CERTIFICATE OF APPROPRIATENESS

Applicant: Jose Cordova, agent, Brickmoon Design, for Tamsiri Laoboonraung owner

Property: 1131 Allston Street, Lot 5, Block 203, Houston Heights Subdivision. The property includes a historic 1,242 square foot, one-story wood frame single-family residence and a 613SF two-story detached garage situated on a 6,600 square foot (50' x 132') interior lot.

Project: 1131 Allston St.
Houston Heights West Historic District

FIRST FLOOR PLAN

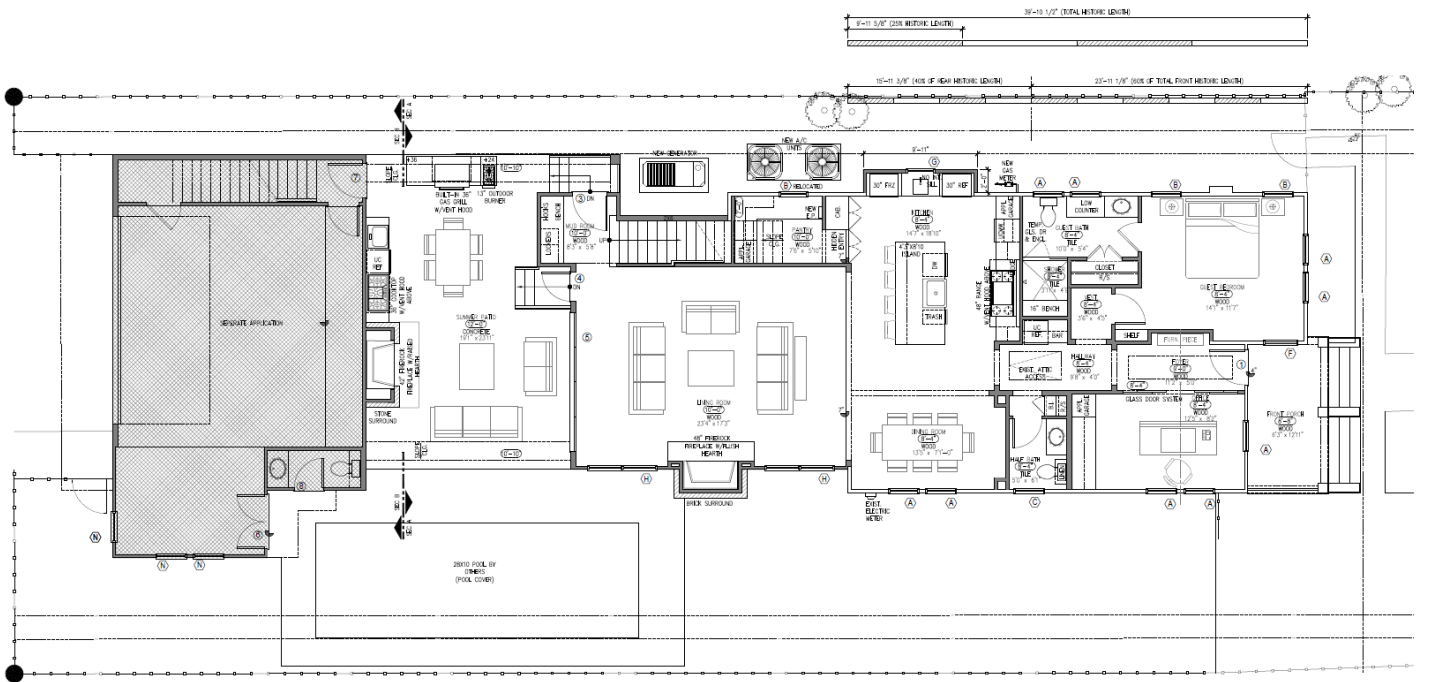
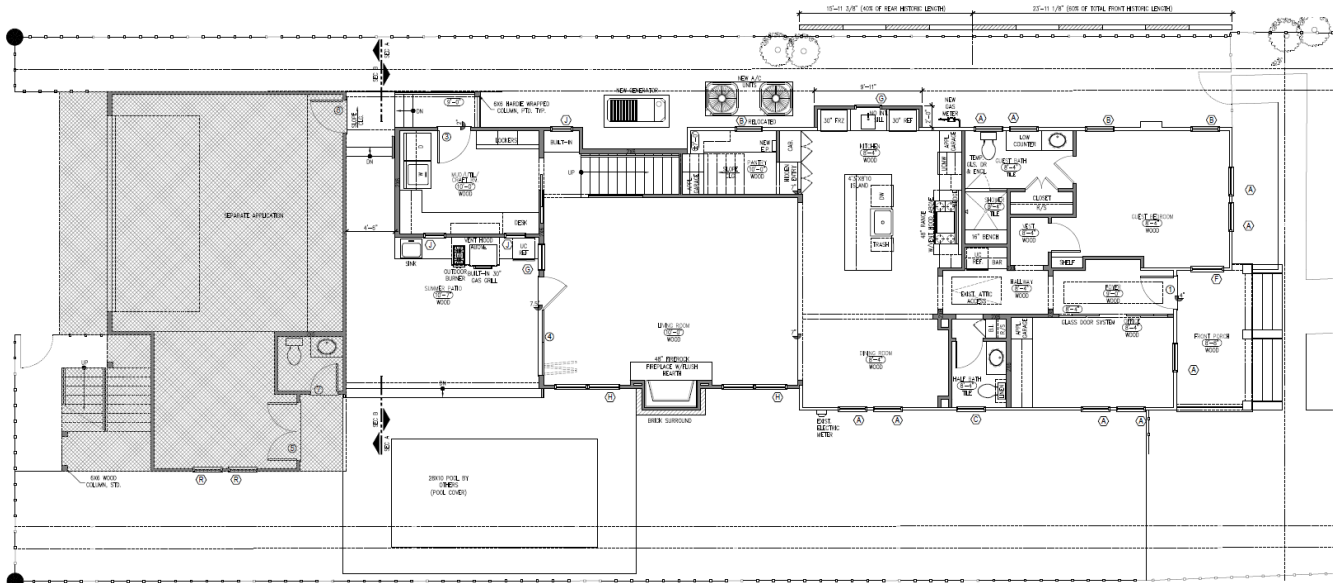
2. Commissioner stated that the patio was too large for historical context.
 - a. By bringing program from upstairs down to the first floor, the patio decreased in size. The previous patio was 19'-1" x 23'-11" and is now 17'-9" x 13'-11".

SECOND FLOOR PLAN

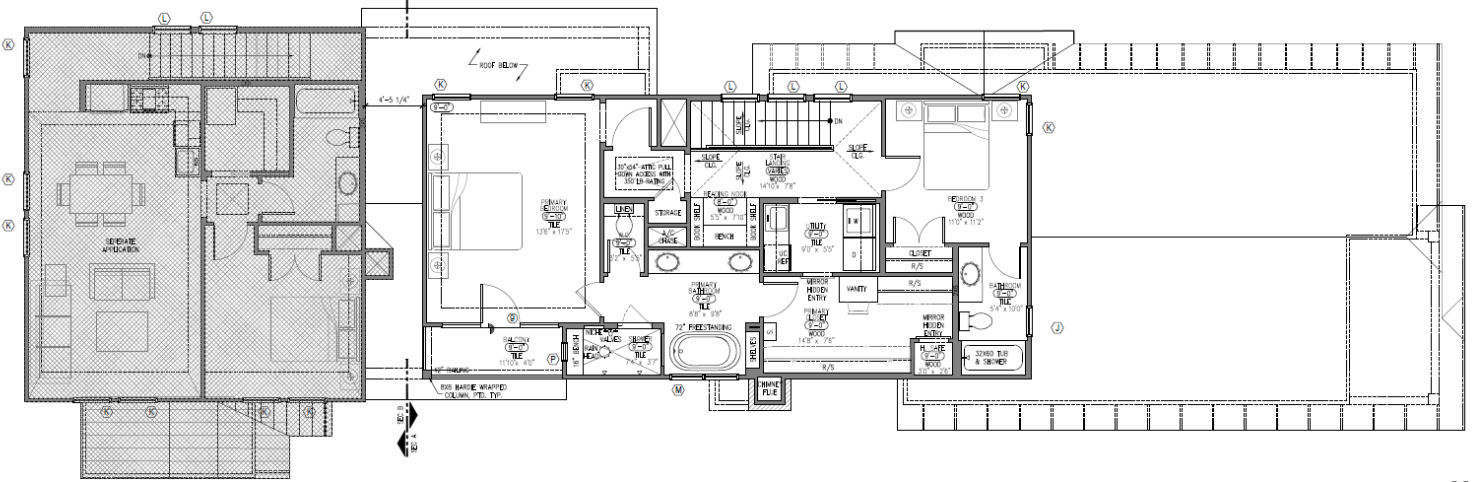
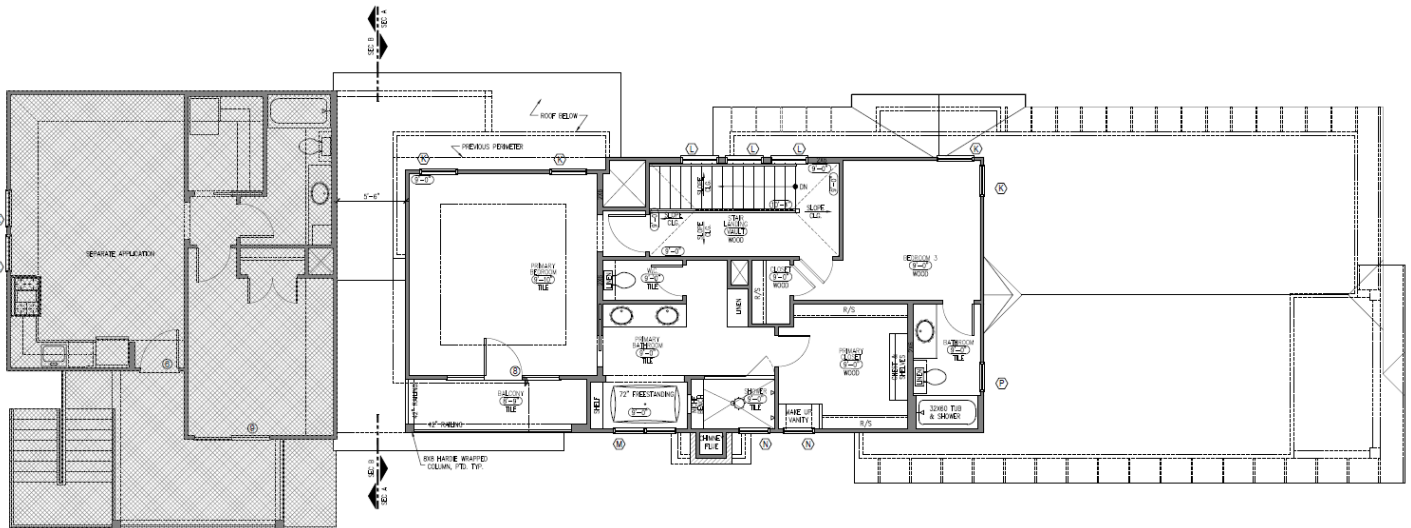
1. Commissioner suggested to bring program downstairs to reduce volume of the second floor.
 - a. Utility room and study area were relocated to the first floor. Additionally, we pinched in the width of the primary bedroom so that the exterior north wall on the second floor is broken up versus having one long wall. The space between the wall of the second floor primary suite and garage increased from 4'-5" to 5'-6". A dashed line has been drawn on the second floor plan to show where the previous perimeter of the second floor plan design was.

ROOF PLAN

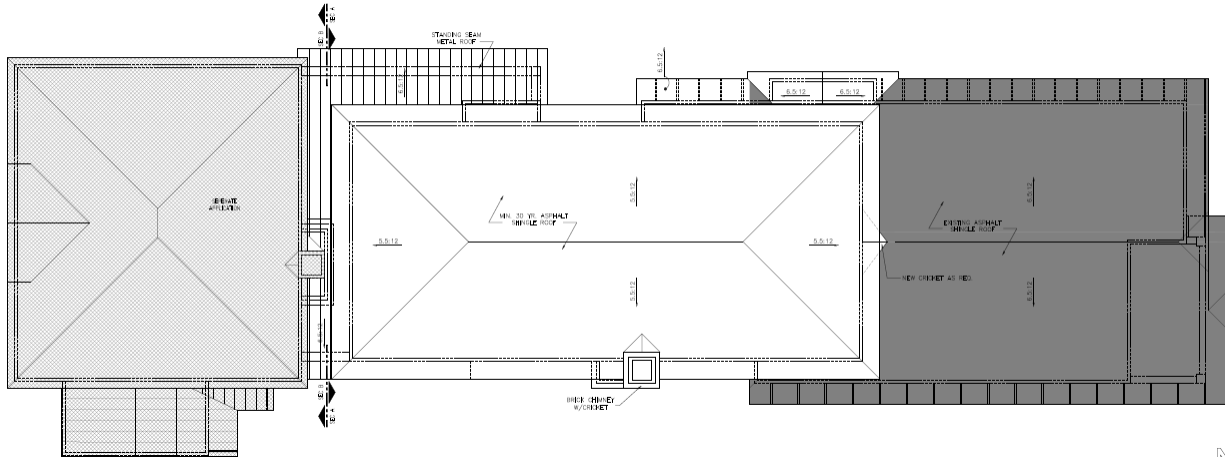
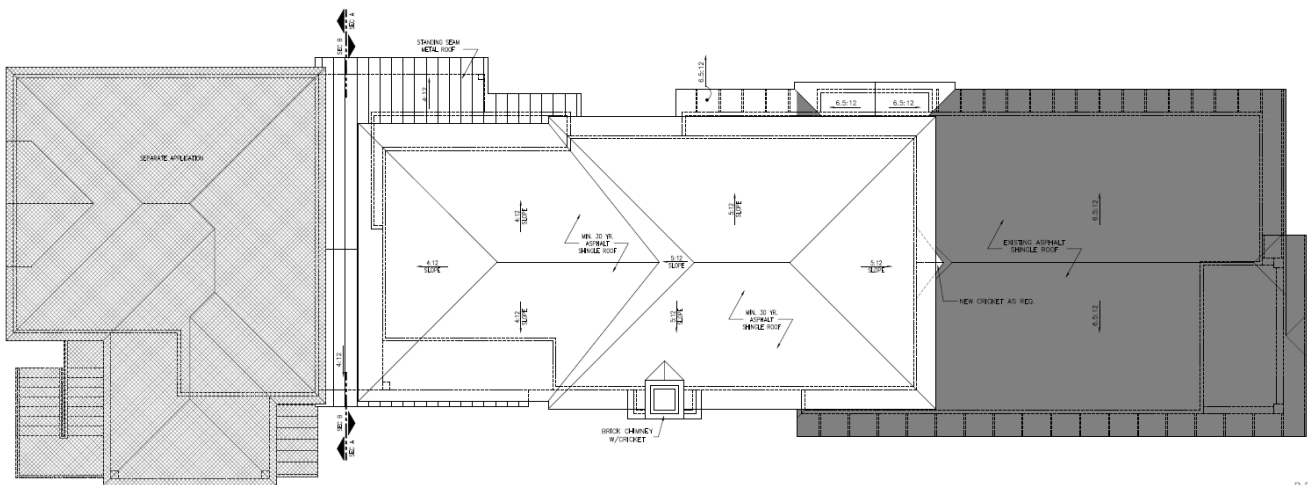
- b. The roof over the primary suite was also redesigned to minimize volume. The roof slope above the master suite is 4:12 which decreases the volume of the roof that you would see from the street.

3. Commissioner stated the connection piece between garage and main residence was too large in volume.
 - a. Our previous design showed a 6.5:12 slope for the roof on the connection piece. We have redesigned it to show a 4:12 to minimize volume. We would like to keep it at 4:12 in case we have to switch over to shingle roofing which require a minimum of a 4:12 pitch to be granted warranty by contractors.
